WALLARAH 2 COAL PROJECT

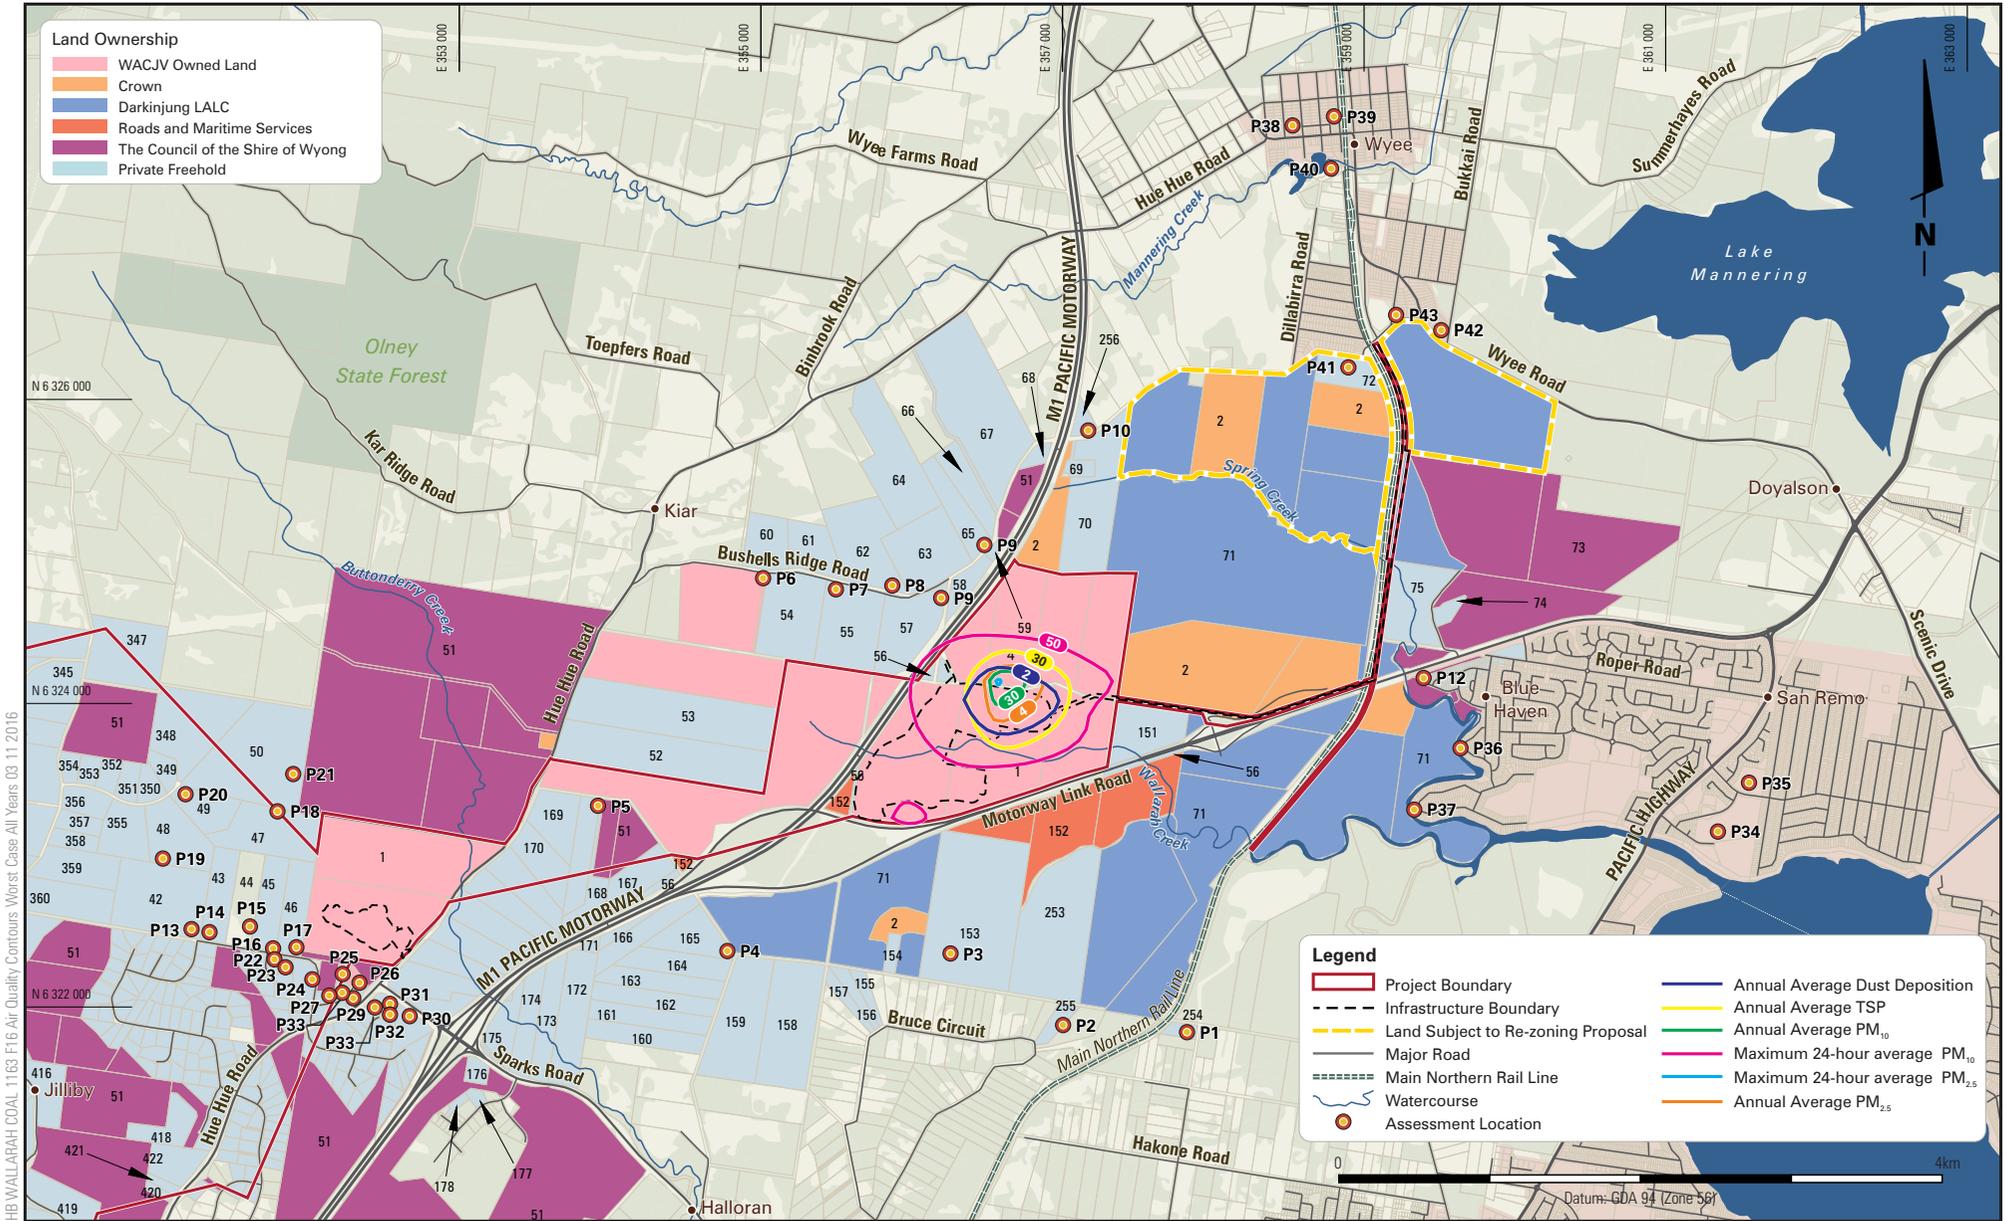
The EIS does not provide adequate consideration of the potential impacts of the amended development on potential future adjacent land uses. For example, land to the north of the proposed rail spur (240 metres) has recently been granted conditional Gateway approval for low-density residential allotments, rural residential land and a small amount of commercial development. The Department notes that 'sensitive receivers' do not currently exist on this land, nor is there any immediate likelihood of this; however the potential impacts on privately-owned land (vacant or otherwise) should be considered.

WACJV has considered the potential amenity impacts to the proposed residential land (as presented in the Planning Proposal).

As shown in **Figure 16**, the Amended Project will not result in any exceedances of the regulatory air quality criteria over the proposed residential land.

Approximately 9.8 ha of the land subject to the rezoning proposal is expected to experience noise levels greater than the amenity criterion of 50 dBA. Approximately 3.3 ha of this land is within the area that is proposed for residential development (see **Figure 17**). This represents approximately 1.1% of the land subject to the rezoning proposal. The night period is the most sensitive period for noise, as the amenity criterion is the lowest for this period. The predicted worst case noise levels for the night period are presented in **Figure 17**.

The *Voluntary Land Acquisition and Mitigation Policy* (VLAMP) provides that rights to land acquisition will arise where the amenity criteria is exceeded over more than 25% of privately owned land. Based on the conceptual lot boundaries presented in the Planning Proposal, there are approximately 25 lots where the night time amenity criterion (50 dBA) is exceeded over more than 25% of the land area (refer to **Figure 17**).

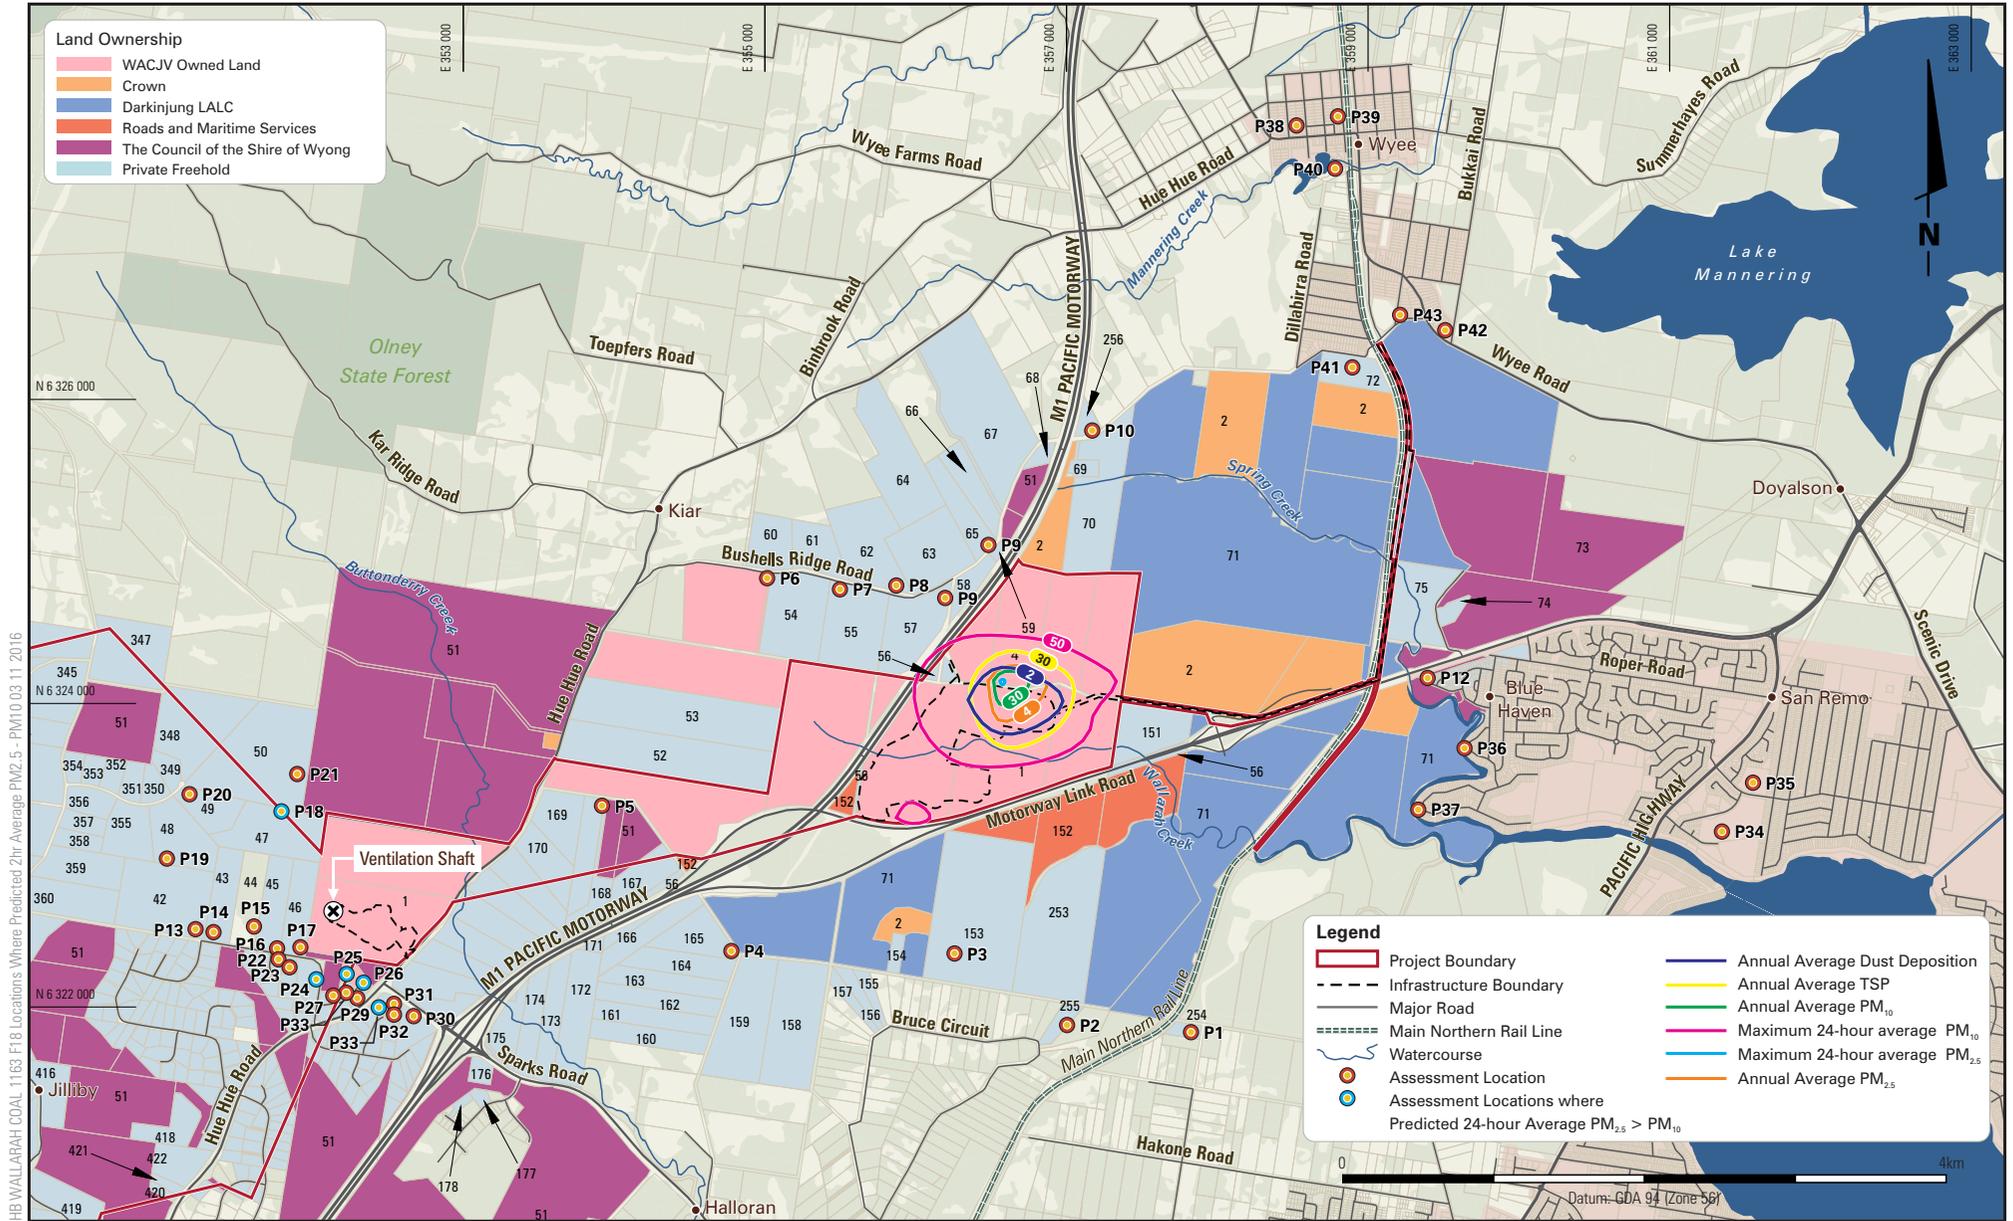
Table 7.1 of the assessment presents a summary of modelling results for $PM_{2.5}$, PM_{10} and TSP. In some instances, maximum $PM_{2.5}$ predictions are marginally higher than the maximum PM_{10} predictions. As $PM_{2.5}$ is a sub-fraction of PM_{10} , these results appear to be in error. The proponent should check and confirm the modelling results presented in the air assessment are correct.

The predicted 24-hour average concentrations (average daily production scenario) are presented in **Table 8**. There are five receptors (P18, P24, P25, P26, and P29) where the modelled PM_{2.5} concentrations are 0.01 µg/m³ greater than the modelled PM₁₀ concentrations. As shown on **Figure 18**, all five of these receptors are in close proximity to the ventilation shaft at the Buttonderry Site. Other receptors (P13 – P33) in the vicinity of the Buttonderry Site also have very similar or identical predictions for both PM_{2.5} and PM₁₀.

* Values in **bold** indicate locations where predicted PM_{2.5} > PM₁₀
